收件者: tpbpd/PLAND  
主旨: Fw: S. 16 Planning Application No. A/YL-KTN/1181 - Departmental Comments  
附件: AYL-KTN 1181 20260424.pdf

### 有關城市規劃委員會對 A/YL-KTN/1181 的查詢

3 cases comments on 23-3-2026

Title: Drainage Proposal - LAYOUT		D01
Drawn by: DM	Date: 23-4-2026	
Check by: DM	Scale: ---

圖 1: (紅圈為樹木的大約位置)

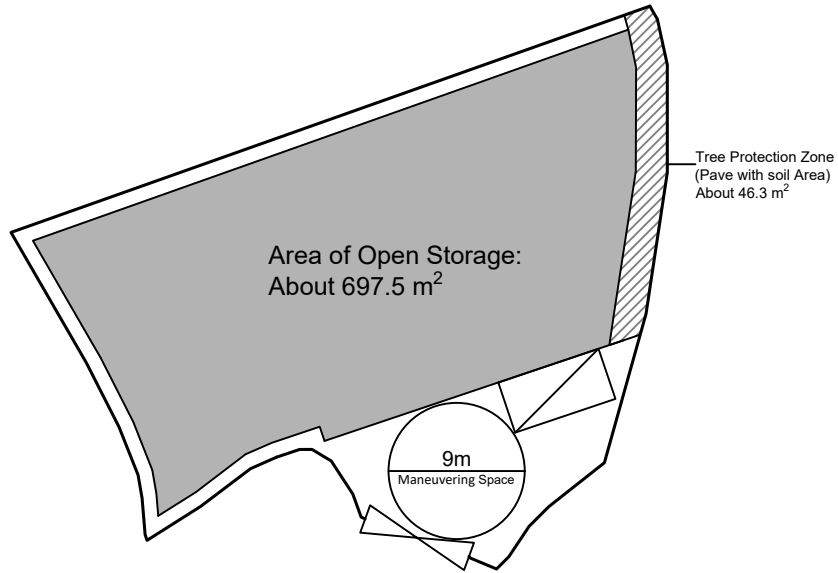
根據高空圖（圖 1），大約 2025 年 6 月份，申請範圍內有約六至八棵樹木分散在申請範圍內，由於申請範圍內的樹木是因長期未有管理下生長，申請範圍沒有任何人工種植的樹木。申請範圍內全部樹木的品種亦屬於香港常見品種或入侵性品種，而有部分樹木的根部已被薇金菊包圍。有見及此，申請地點內的樹木未有保留。申請人亦為此事致歉。

Appendix 7

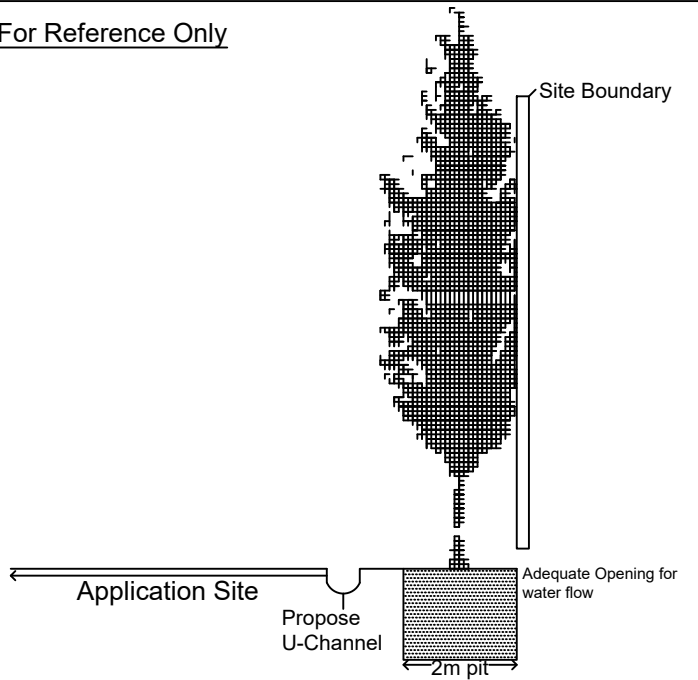
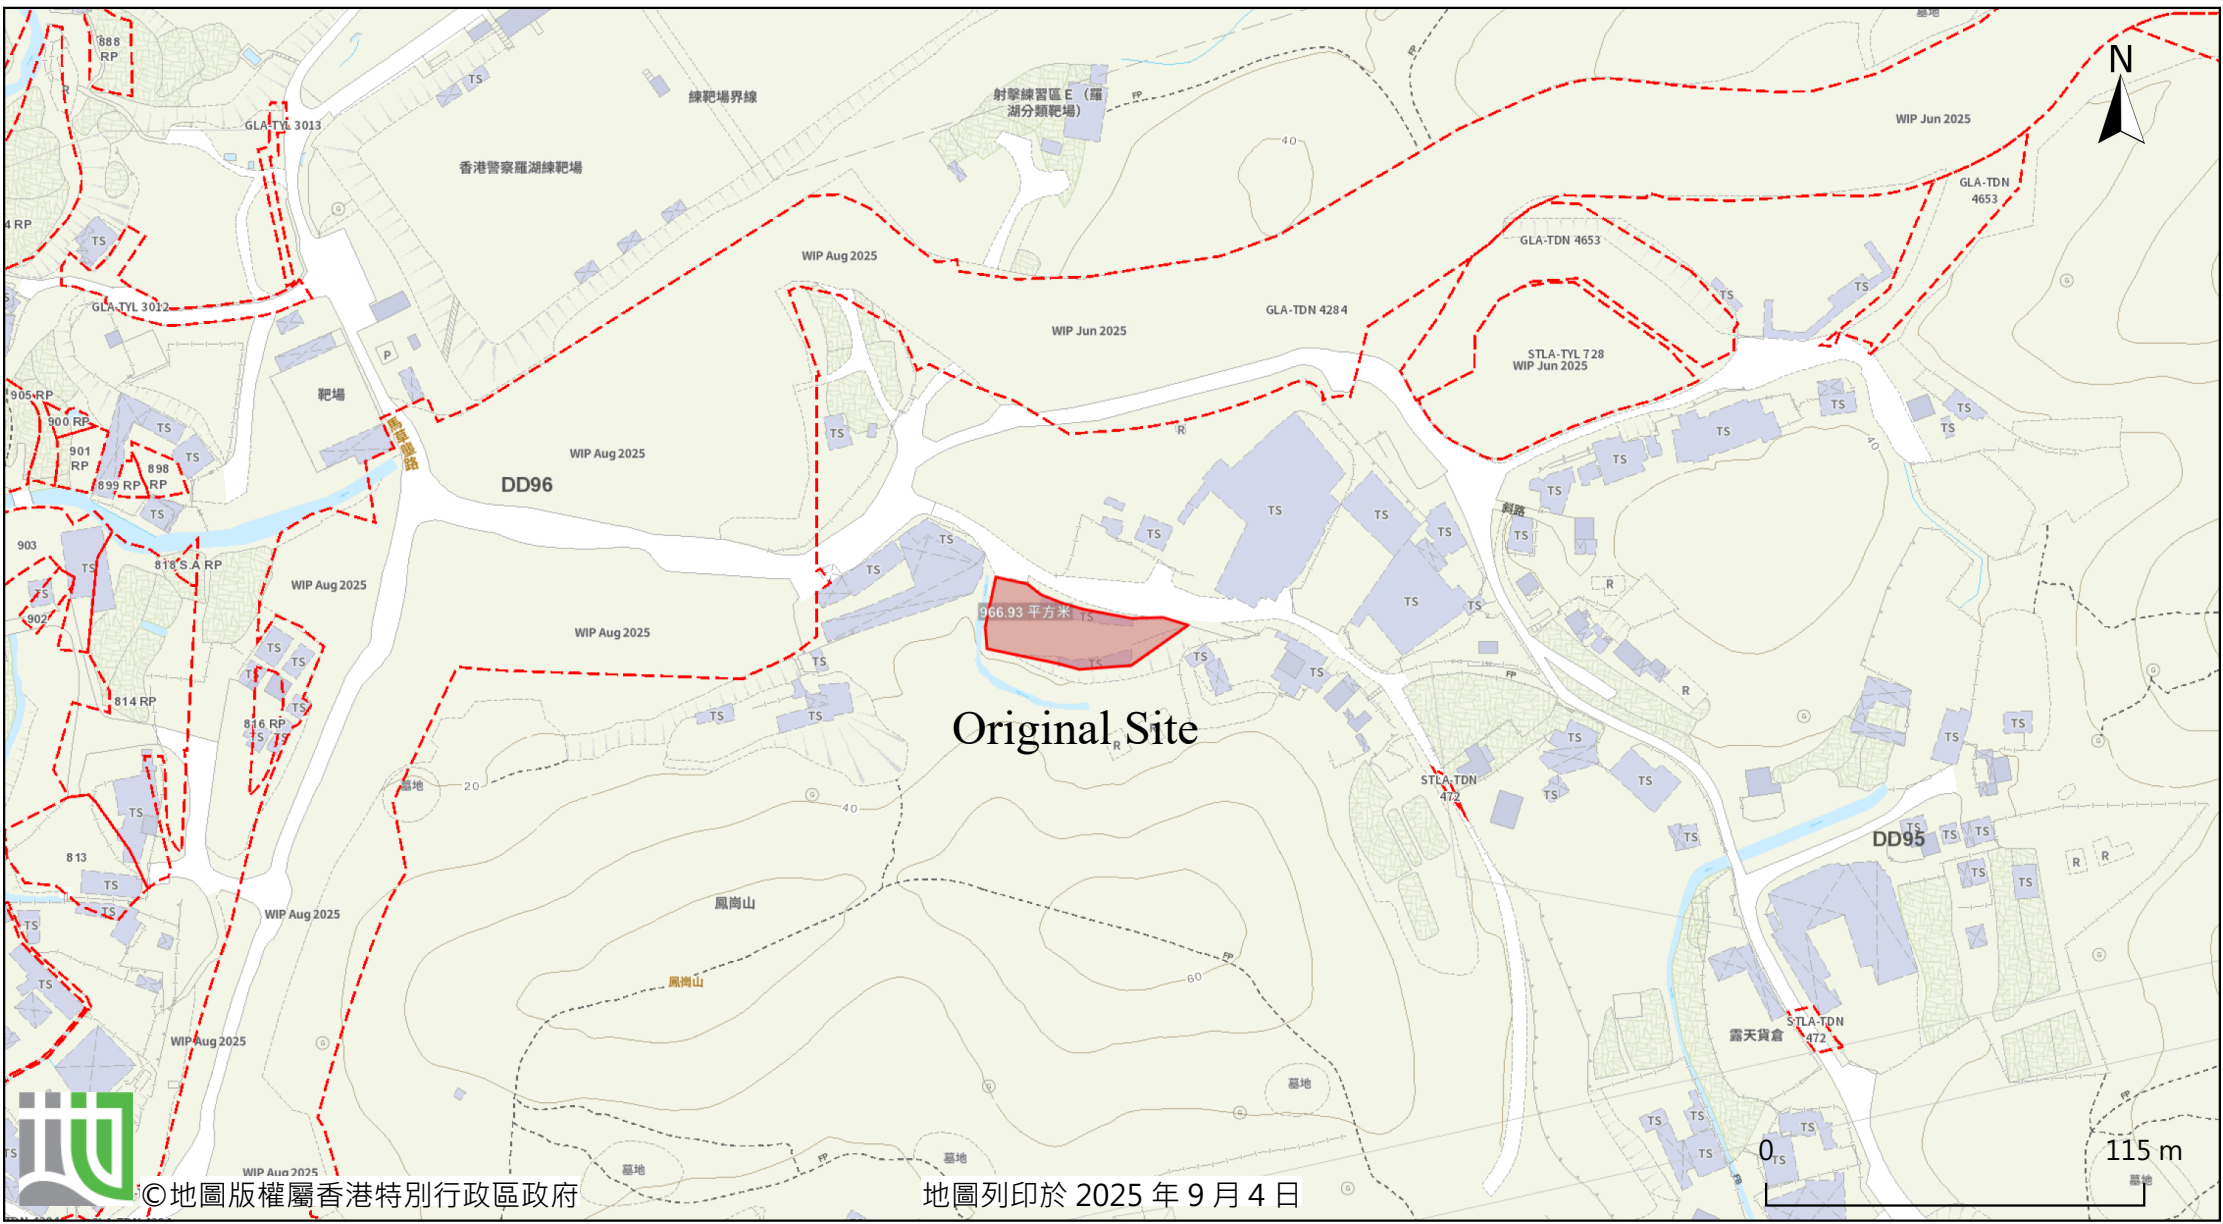
綠化方面，申請範圍內計畫重新種植八棵竹柏，並會在樹幹 2 米範圍設有 2 米乘 2 米的保護區，保護區不會放置任何物品，以免影響樹木生長。樹木會定期檢查、修剪及除去入侵性的雜樹，從而保護樹木。種植範圍約有 46.3 平方米，請參考 Appendix 4 及 Appendix 7。

Plants: Nageia nagi  
 Approximate Height: 2.75m - 3m  
 Unit(s): 8  
 \*All Proposed plants are at-grade planting.  
 \*The size of the tree pit will be at least 2m x 2m with soil depth of 1.2m.

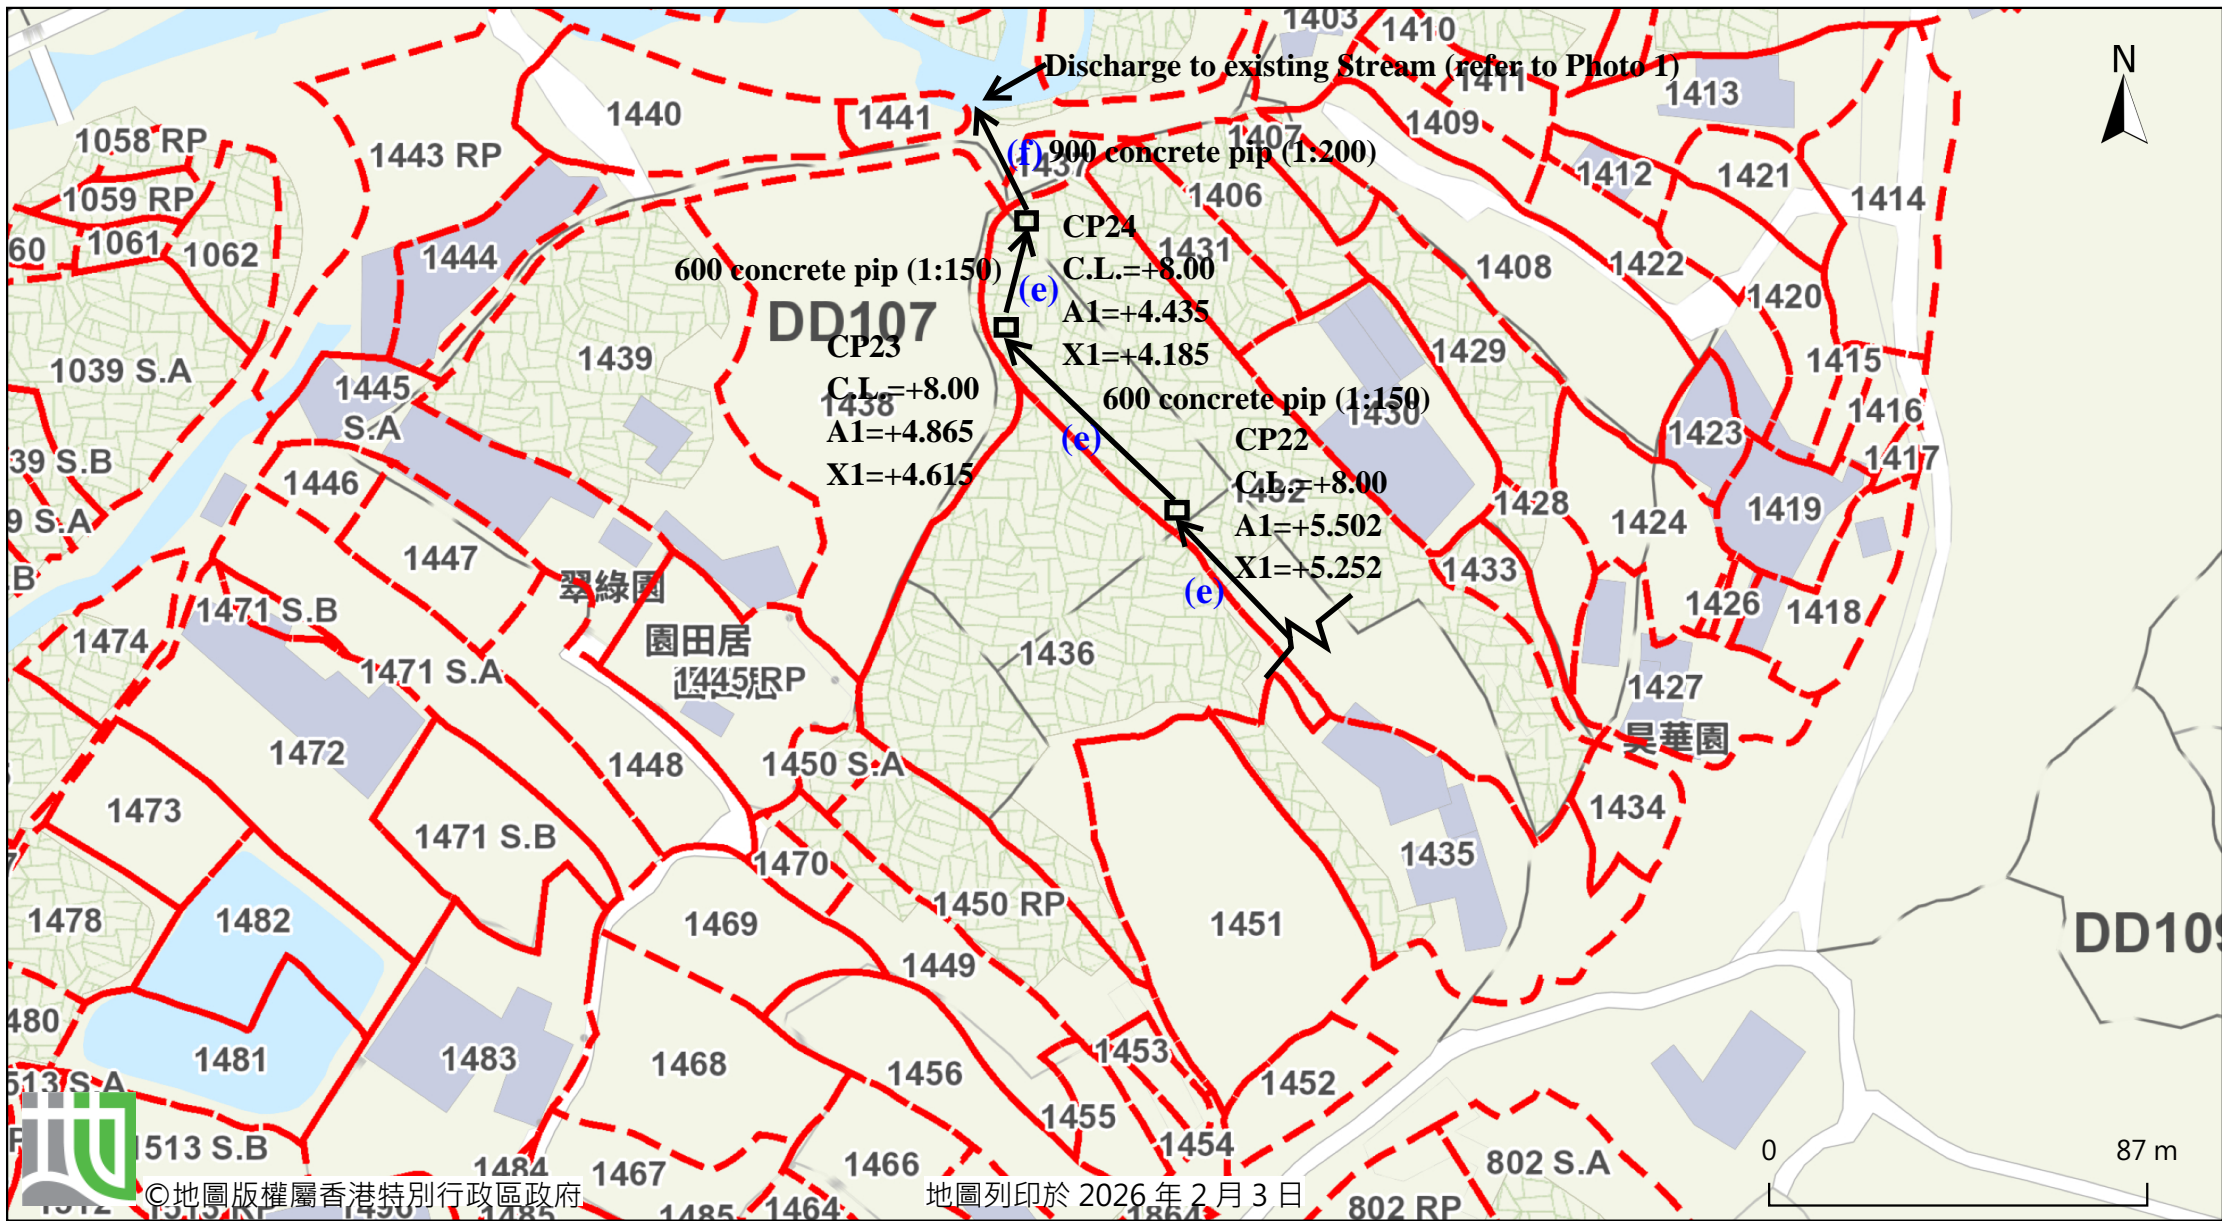
1. Drawings (No.: D01 & D01a): The applicant should clarify discrepancy of size of the proposed stormwater drainage pipe at the downstream of catchpit CP24 mentioned in the proposal.

2. The applicant should clarify discrepancy of gradient of the proposed drainage facilities shown in drawing (No.: D01) and the submitted hydraulic calculation. Also, the applicant should clarify discrepancy of surface runoff 'Q3' shown in the submitted hydraulic calculation and chart.

3. Drawing (No.: D01): The proposed 900 mm dia. stormwater drainage pipe is missing on the submitted drainage plan.

**It is revised accordingly.**

**It is revised accordingly.**

**It is revised accordingly.**

**Catchment Area Plan**

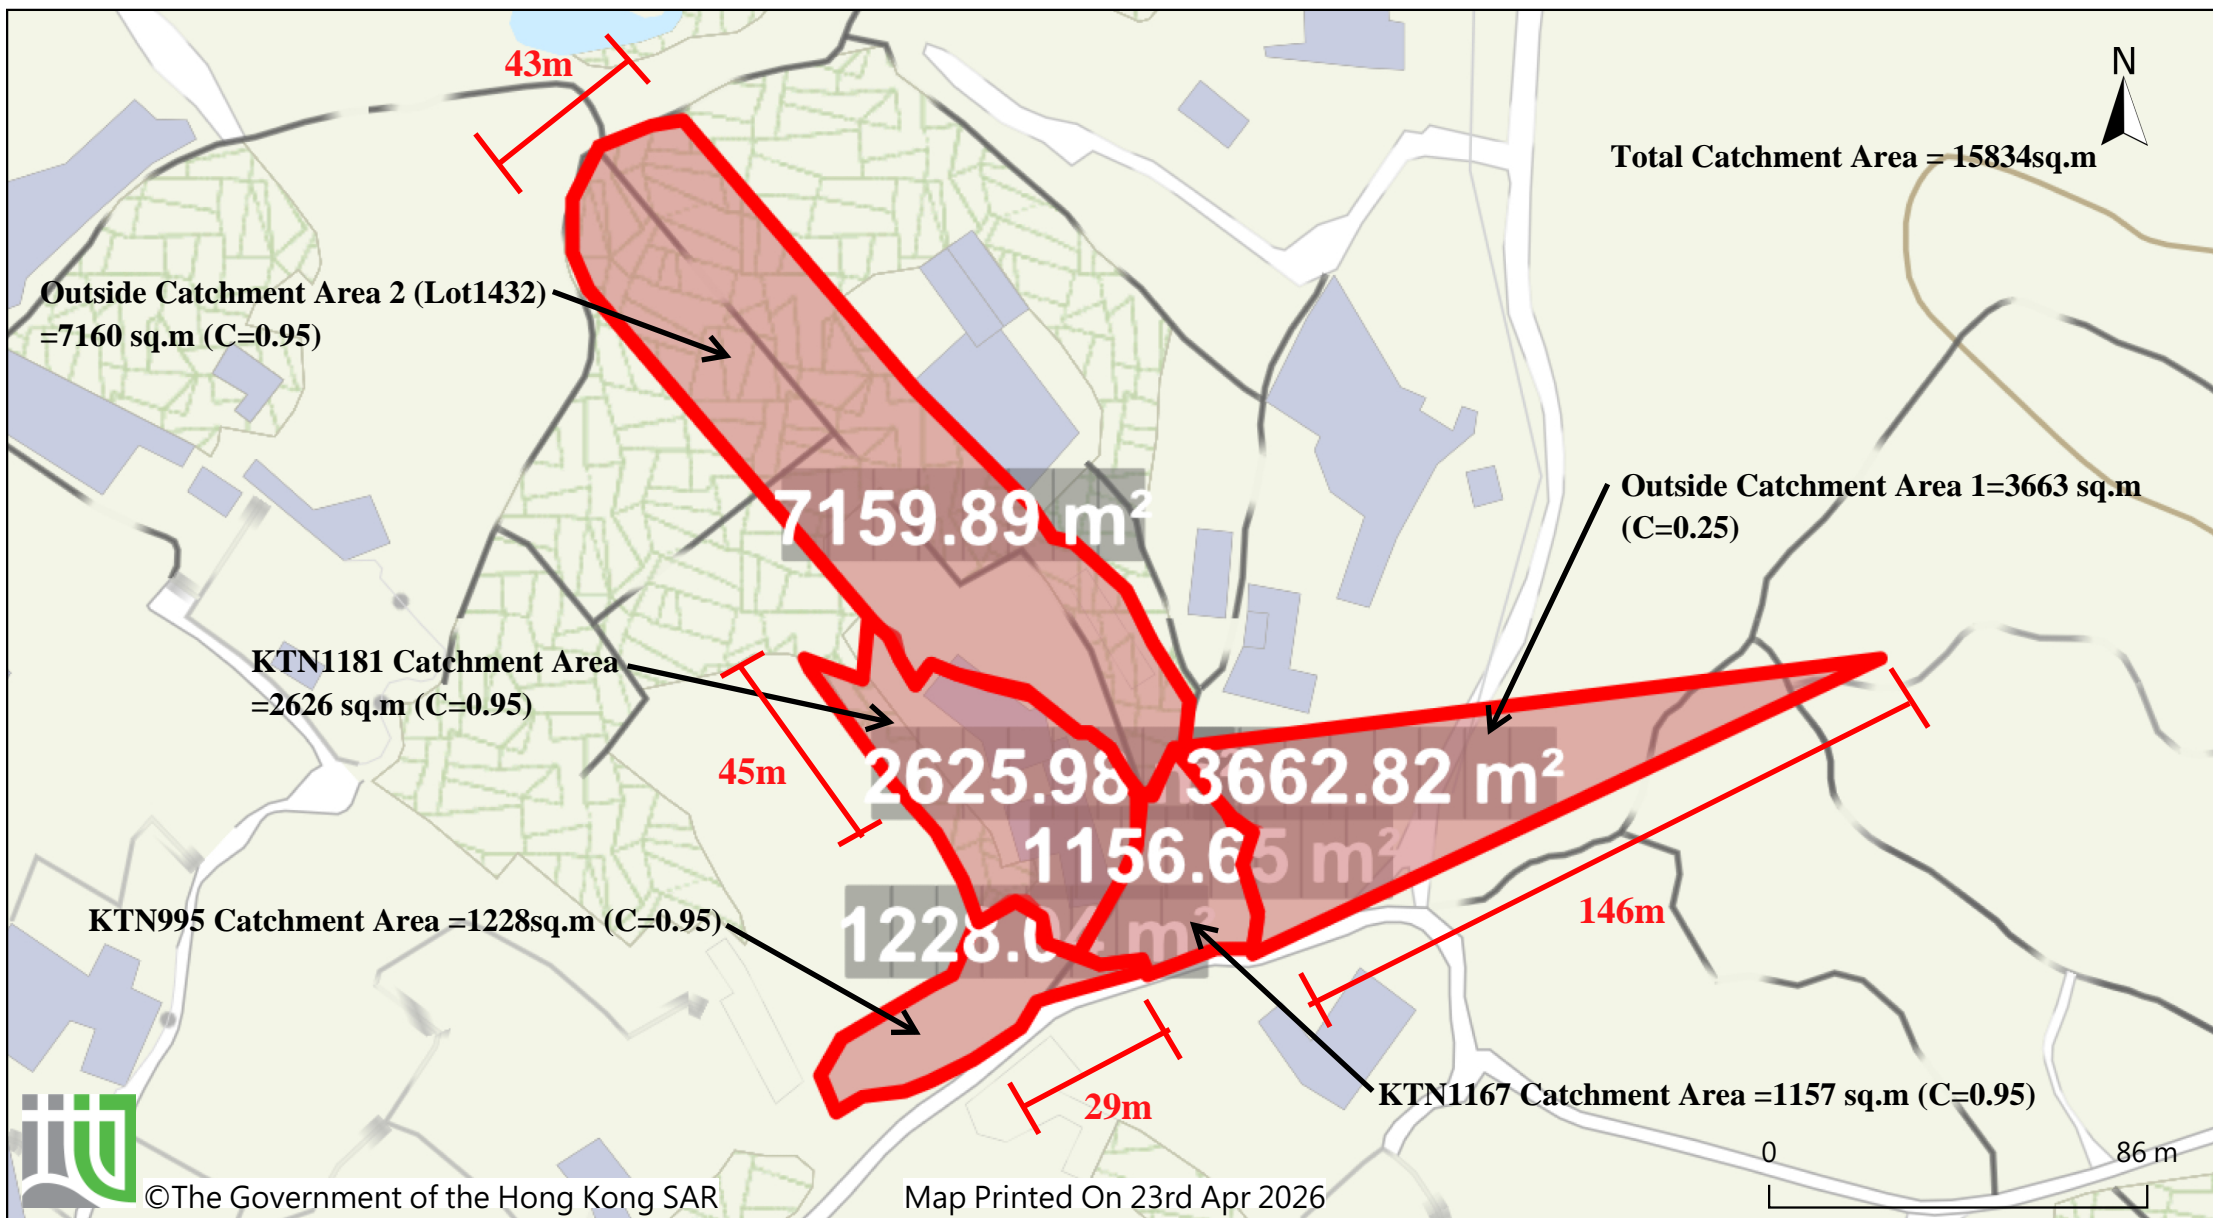
5. According to the topography, catchment area of site under another planning application (No.: A/YL-KTN/995) is underestimated. Also, the applicant should clarify why external catchment area of site under another planning application (No.: A/YL-KTN/1181) is 2661 m<sup>2</sup>. Besides, the applicant should evidence to support adoption of 6938 m<sup>2</sup> as external catchment area of site under another planning application (No.: A/YL-KTN/1181) and demonstrate with hydraulic calculation that the proposed 600 mm dia. stormwater pipe (at the downstream of the proposed catchpit CP16) are adequate to collect, convey and discharge the surface runoff accrued on the application site and the overland flow intercepted from the adjacent lands.

**The catchment area plan is revised and hence the calculation.**
